# City of Sandy

### Planning Commission Meeting

**Meeting Date:** February 25, 2019  
**From** Emily Meharg, Associate Planner  
**SUBJECT:** Jacoby Heights Subdivision

All County Surveyors & Planners submitted an application on behalf of Cory Knight to subdivide 9.68 acres at 19124 Jacoby Road into a 32 lot subdivision. The 32 lots range in size from 7,500 square feet to 21,183 square feet. The subdivision proposal includes the extension of Newton Street into the site and three proposed local streets: Camden Court, Woodstock Street, and Middlebury Avenue. The applicant is requesting three (3) variances: a variance to Section 17.82.20 to allow future homes to not orient to Jacoby Road, a variance to Section 17.100.120(A) to allow a one-tiered lot configuration between Jacoby Road and Camden Court, and a variance to Section 17.100.120(B) to exceed a 400 foot block length on the north side of Woodstock Street between Camden Court and the east property line. In addition, the applicant is requesting a code interpretation related to the tree protection standards of Chapter 17.92, Landscaping and Screening General Standards – All Zones, and Chapter 17.102, Urban Forestry.

32-LOT SUBDIVISION  
PRELIMINARY PLAT MAP  
DECEMBER 2018

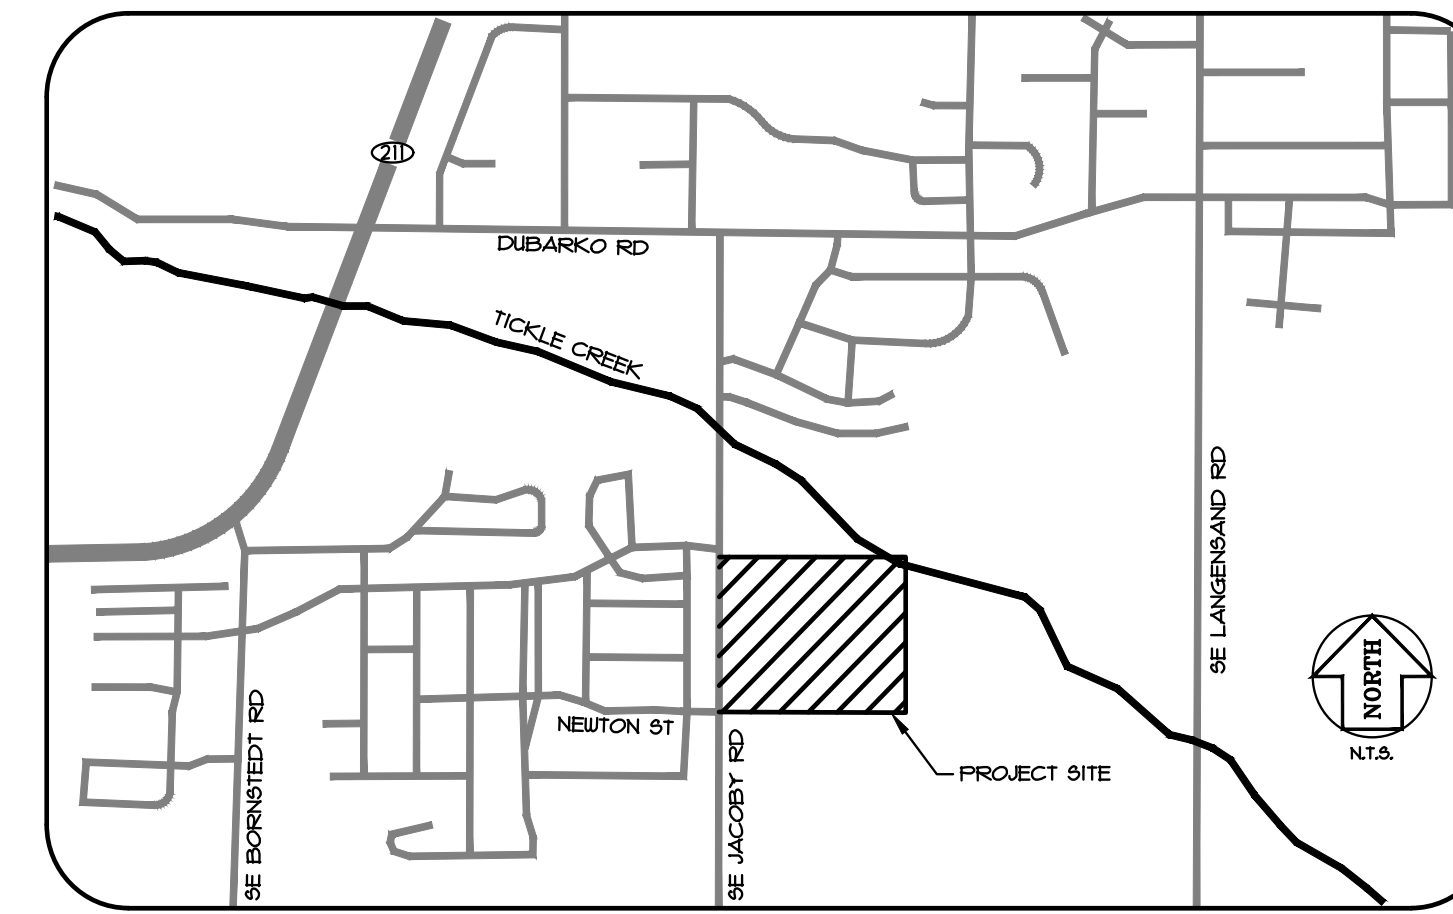
**RESPONSE:** All structures shall maintain a minimum 20-foot setback from the Jacoby Road public right-of-way. The Preliminary Plat (Exhibit C, Sheet 1) depicts building envelopes at 20 feet from the Jacoby Road right-of-way.

***RESPONSE:*** *The Preliminary Plat (Exhibit C, Sheet 1) depicts an 8-foot-wide public utility easement along the frontage of all proposed lots to facilitate future installation of utilities. Sidewalks abutting the proposed lots shall be constructed in association with development of the lots. The applicant shall construct sidewalks along Tract A both on Jacoby Road and Camden Court, prior to final plat approval. The sidewalks on Camden Court, Woodstock Street, Newton Street, and Middlebury Avenue shall be five feet in width and separated by a planter strip or swale (six feet in width) in areas not transverse by driveways. The sidewalks on Jacoby Road shall be six feet in width and separated by a five foot planter strip.*

**RESPONSE:** *The Preliminary Plat (Exhibit C, Sheet 1) does not show the correct measurement of 50 feet of tangent alignment at the intersection of Jacoby Road and Newton Street as required by 17.84.50(H.5.b). The applicant measured the 50 feet of tangent alignment from the centerline of Jacoby Road rather than from the curb line extended. The applicant shall revise the alignment of Newton Street to conform to the 50 feet of tangent alignment standard.*

**RESPONSE:** Garages are required to be at least 22 feet setback from the front property line to meet setback requirements in the SFR zoning district. The Preliminary Plat (Exhibit C, Sheet 1) details a typical 22 foot garage setback.

***RESPONSE:** The Preliminary Plat (Exhibit C, Sheet 1) details an 8 foot wide public utility easement along all street frontages. The plat shall detail all proposed easements as detailed in Section 17.84.90 above.*

BY	1	SHEET	5
REVISION		OF	10
DATE		DESIGNED	CTH
		DRAWN	CTH
		CHECKED	RLT
		APPROVED	RLT

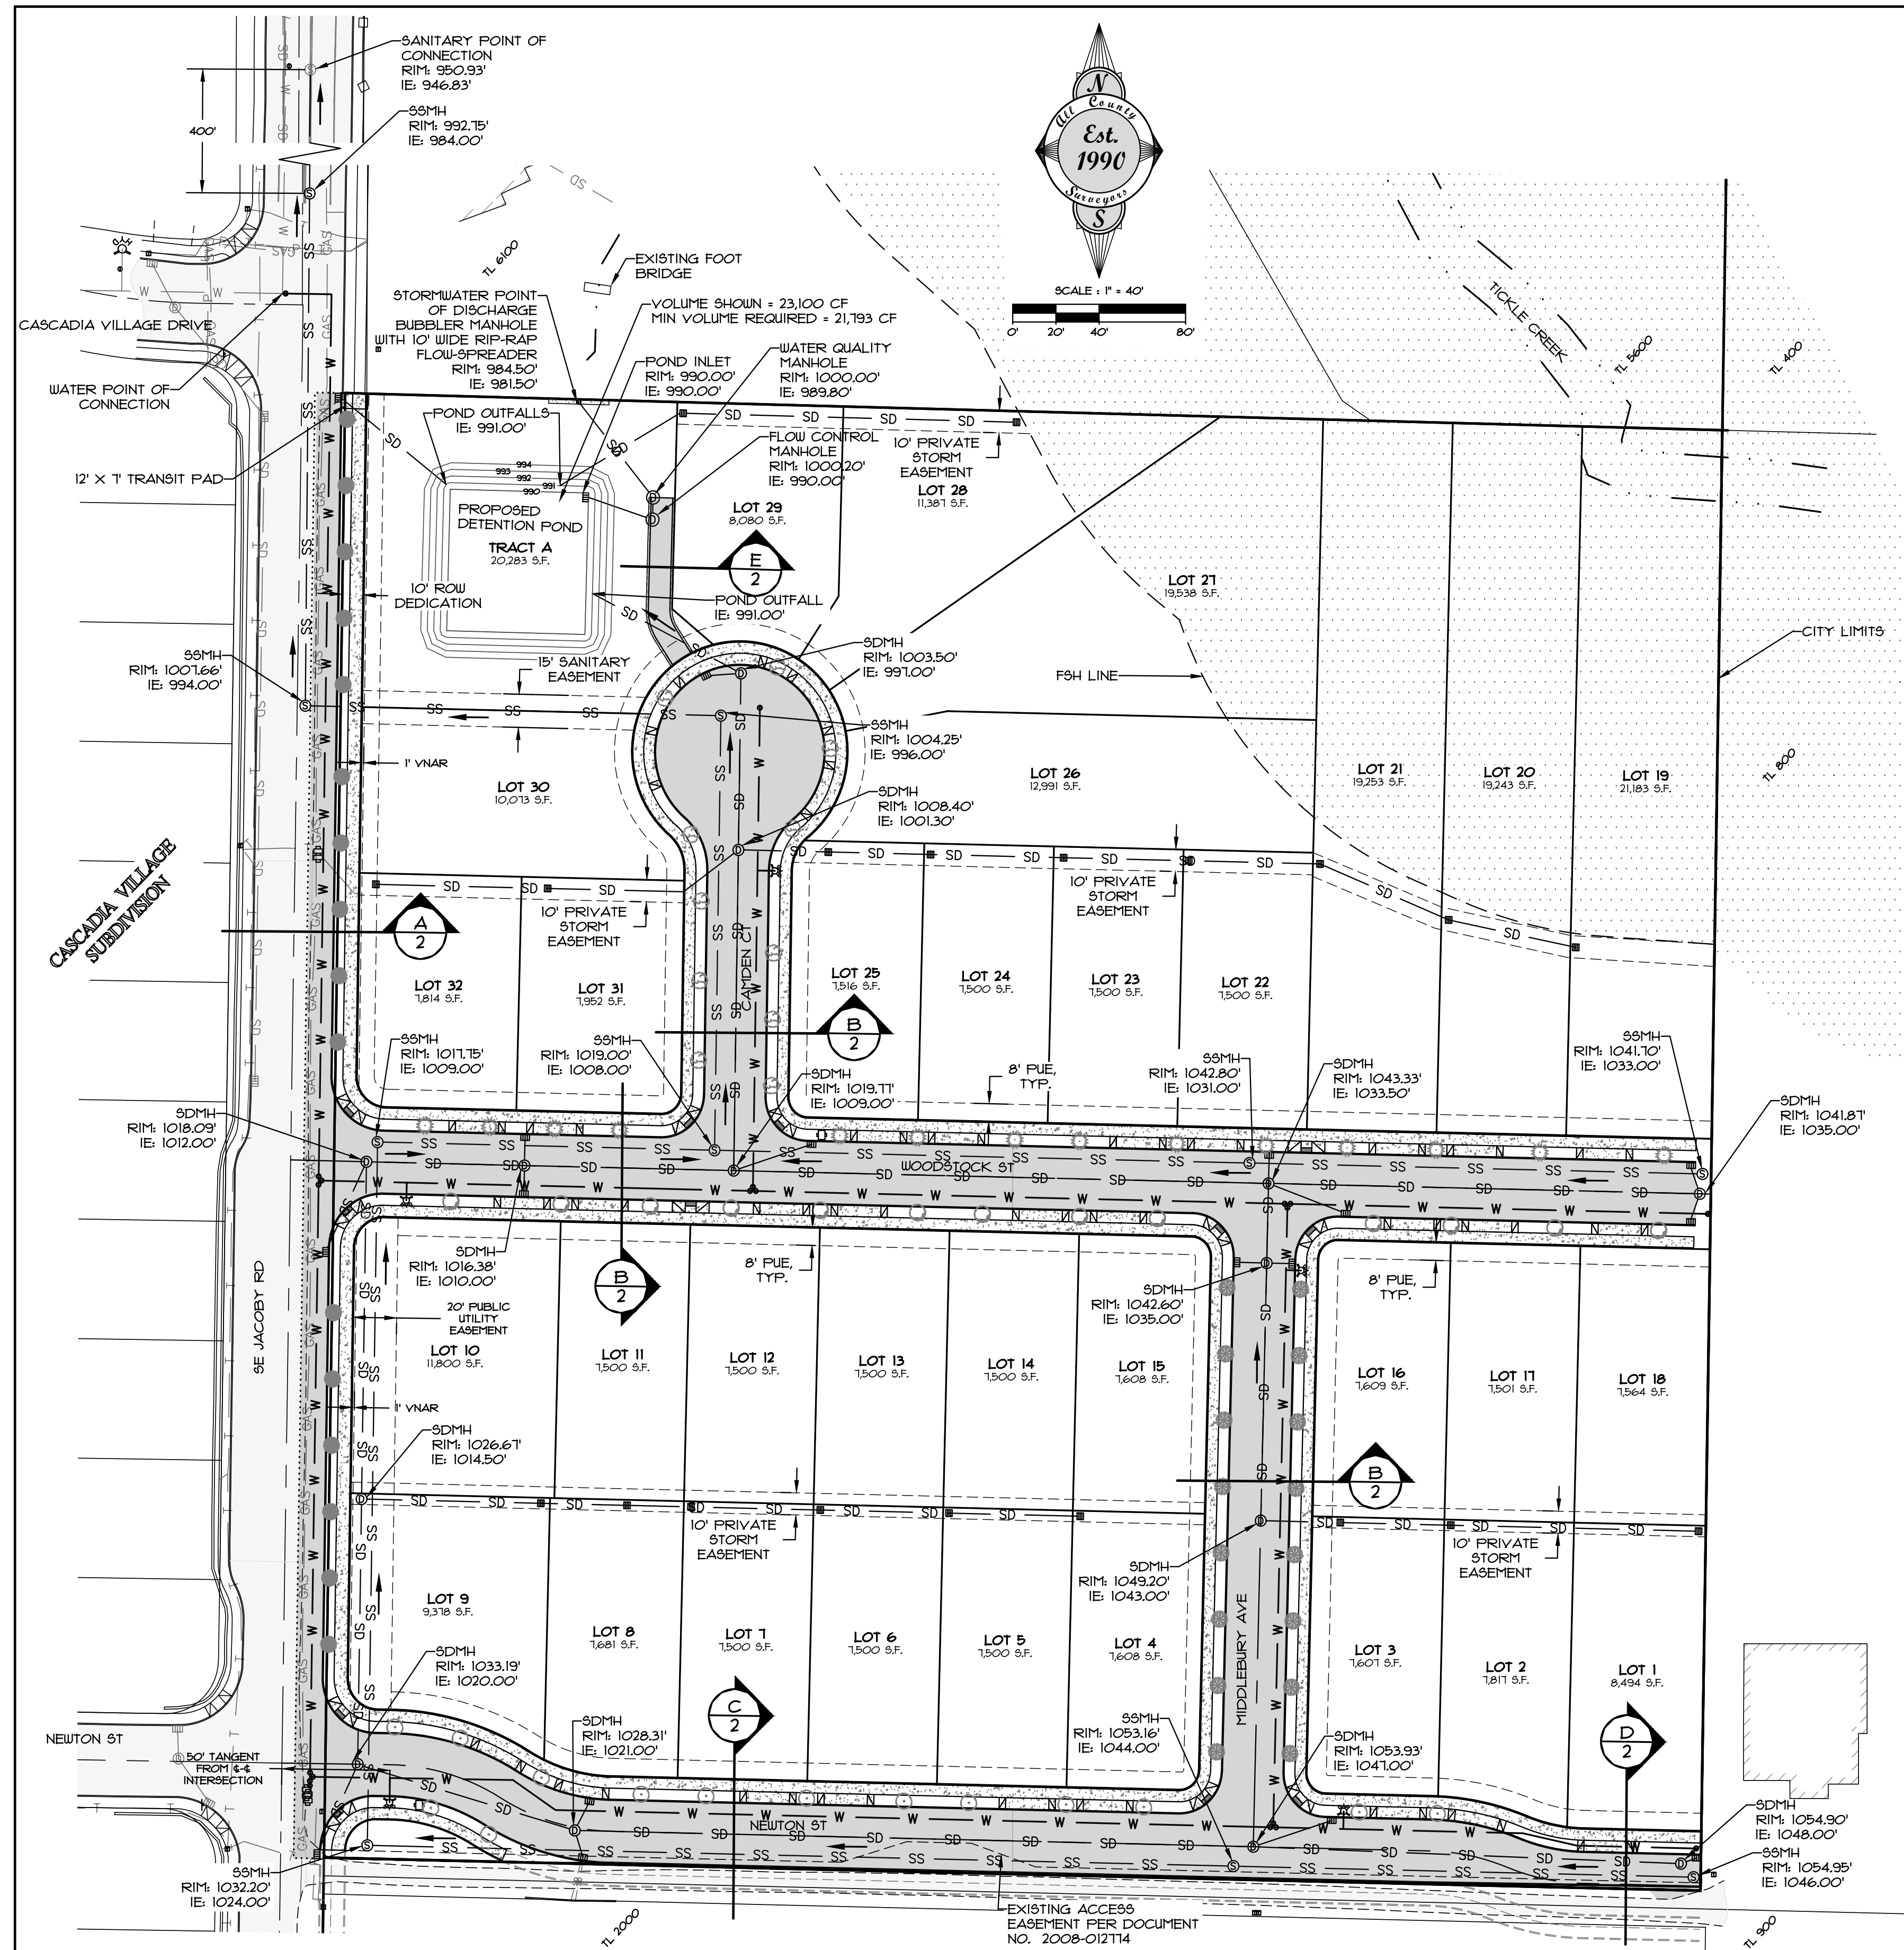
*surface, curbs on both sides, 5-foot planter strips and 5-foot sidewalks on the north side of the roadway. The preliminary street and utility plan (Exhibit C, Sheet 5) shows the sidewalk and planter strip improvements on the south side of Newton Street across from Lot 9 ending before the development site boundary. Section 17.84.50(E) requires extension of street improvements “to the edge of adjacent properties.” **The applicant shall extend the street improvements on Newton Street across from Lot 9 to the south line of the development site and obtain slope easements or construct retaining walls as necessary to comply with this section of the development code. Improvements shall include extension of the Newton Street sidewalk and planter strip, one additional street tree, and landscaping the additional 17.70 feet of right-of-way dedication at the southeast corner of Newton Street and Jacoby Road.***

***RESPONSE:*** *The applicant’s Preliminary Street and Utility Plan (Exhibit C, Sheet 5) depicts the location and type of proposed public utilities including water, sanitary sewer and stormwater. All public utility installations shall conform to the City’s facilities master plans. Staff recommends the applicant revise the utility plan to include broadband fiber locations as detailed by the SandyNet Manager. Per the City Engineer (Exhibit L), all public sanitary sewer and waterline mains shall be a minimum of 8 inches in diameter and all stormwater drains shall be a minimum of 12 inches in diameter and shall be extended to the plat boundaries where practical to provide future connections to adjoining properties. No building permits will be issued until all public utilities including sanitary sewer are available to serve the development. The applicant shall pay plan review, inspection, and permit fees as determined by the Public Works Director. The utility improvements proposal and requirements for the Jacoby Heights subdivision are further detailed in Sections 17.100.230, 17.100.240, and 17.100.250 below.*

BY	REVISION	SHEET
		7
DATE	NO.	OF
		10
DESIGNED: CTH	DRAWN: CTH	CHECKED: RLT
APPROVED: RLT

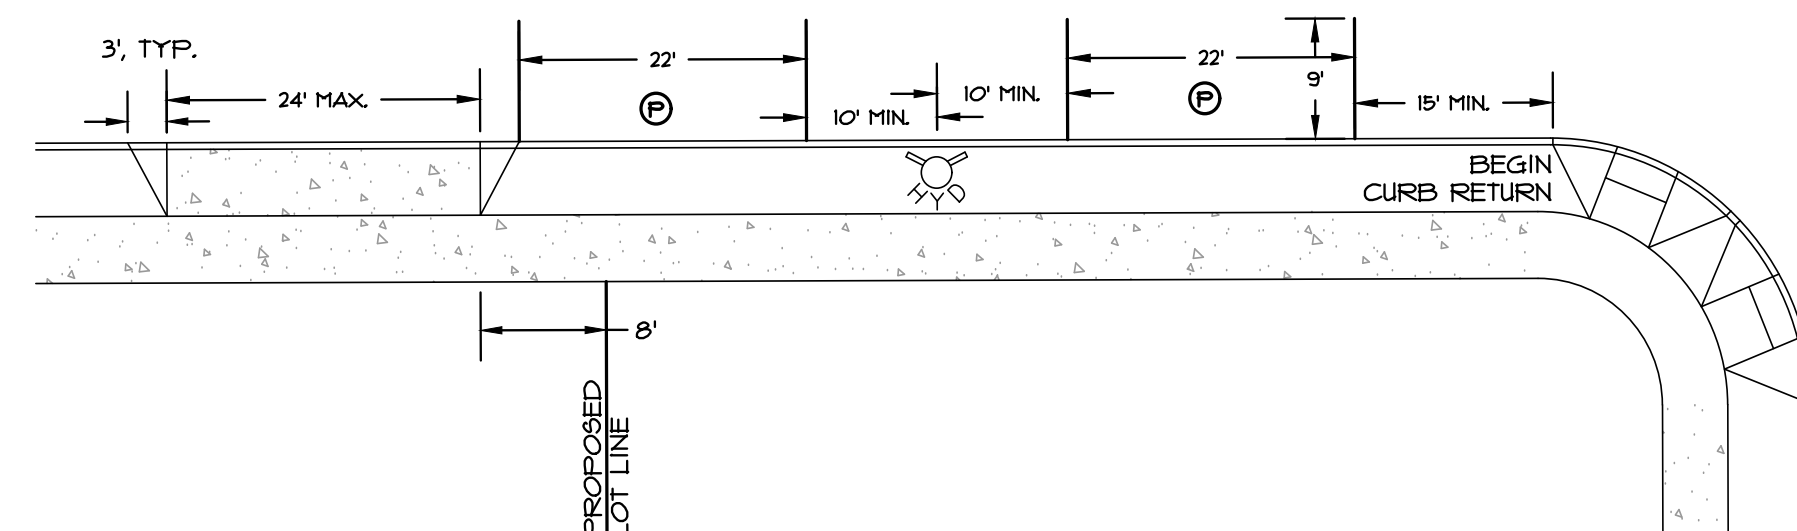
*approach. The Preliminary Parking Plan (Exhibit C, Sheet 7) details driveway curb cuts for all lots. With the exception of a few lots on the cul-de-sac, all driveways are detailed at approximately 20 feet. The applicant is proposing a shared driveway between Lot 29 and Tract A at approximately 36 feet and a shared driveway between Lot 27 and 28 at approximately 26 feet. In order to maximize street tree planting areas and prevent conflicts with streetlights, water meters and dry utility facilities, shared driveway approaches may be required in cul-de-sac bulbs. Per the Public Works Director (Exhibit O), Lot 28 and 29 shall share a driveway approach maximum 24 feet in width. Lot 26 and 27 shall share a driveway approach maximum 24 feet in width. The applicant shall grant crossover easements along the common parcel line to lots with shared driveway approaches. The applicant shall realign the access drive proposed to serve the stormwater facility in Tract A or revise the west line of Lot 29 to eliminate remnant of Tract A between the access drive and Lot 29. The driveway approach for Tract A shall be a maximum of 12 feet in width. Per the City Engineer (Exhibit L), the access to the detention pond shall be paved or all-weather surface.*

**RESPONSE:** *The Preliminary Parking Plan (Exhibit C, Sheet 7) identifies a total of 62 on-street parking spaces with at least one (1) on-street parking space within 200 feet of each of the 32 lots. The proposed parking plan shows 21 parking spaces on the south side of Newton Street, including parking spaces for Lots 1-4. These on-street parking spaces should not be counted toward meeting the on-street parking requirement since the south side of the street will eventually develop with driveways and/or streets that will eliminate these spaces or prevent the developer of the site to the south from counting these spaces toward their on-street parking requirement. Per the Public Works Director (Exhibit O), **the applicant shall revise and resubmit the on-street parking plan for staff review and approval prior to final plat approval. No parking courts are proposed. The location of fire hydrants will be reviewed by the Sandy Fire Department in more detail with Construction Plans. The applicant shall revise the Parking Analysis if required fire hydrants affect on-street parking spaces.***
